# TECHNICAL INFORMATION

## TV EQUIPED OF ICC19 CHASSIS (50Hz and 100Hz)

ICC19 16/9 50Hz CHASSIS →

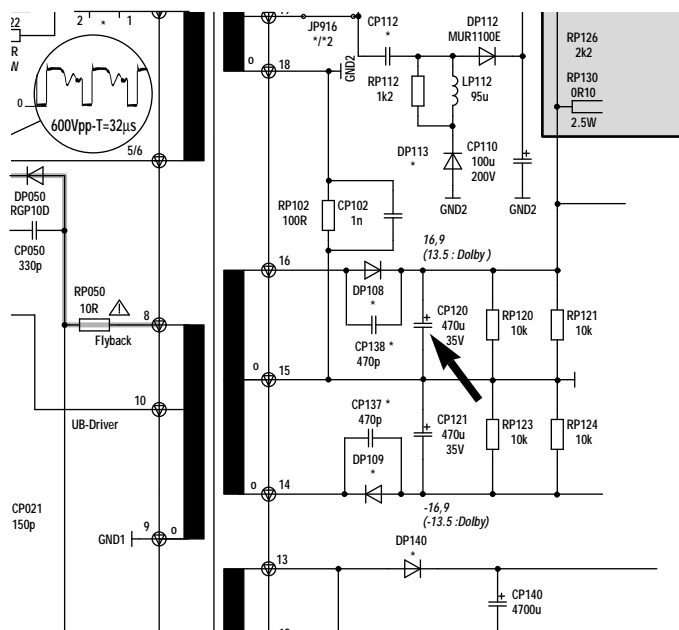
When the television is in the Standby Mode, residual noise can be heard from the loudspeakers.

Change CP120 from 470 $\mu$ F 35V to 330 $\mu$ F 25V capacitor (codice 10448410)

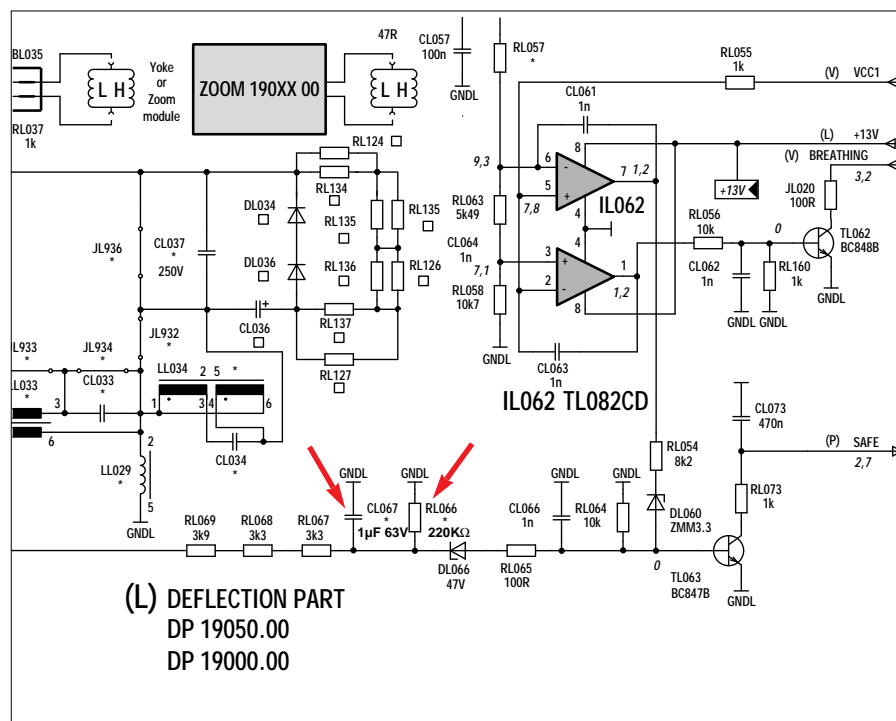
Power supply switches to safety mode during VCR operating.

Loss of synchronisation signal for 1 or 2 frames (poor quality video recording).

- Replace capacitor CL067 (100nF 100V) with a 1μF 63V (Part No. 43067772).
- Add a 220kΩ 5% 100mW melf resistor at position RL066 (Part No. 10328700)
